Technical Service Bulletin

85 Instrument panel vent cannot be opened or closed

85 13 11 2032516/1 January 17, 2013.

Figure 1. Improved instrument panel vent assembly with white mark.

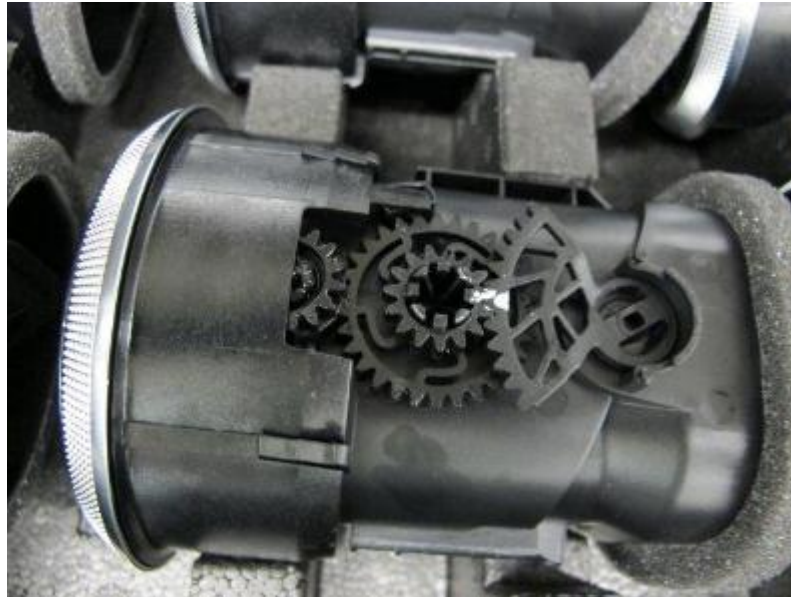
The assembly process was improved and an additional test to the vent assembly was implemented in production. A white mark has been applied to the gears of the improved vents (Figure 1).
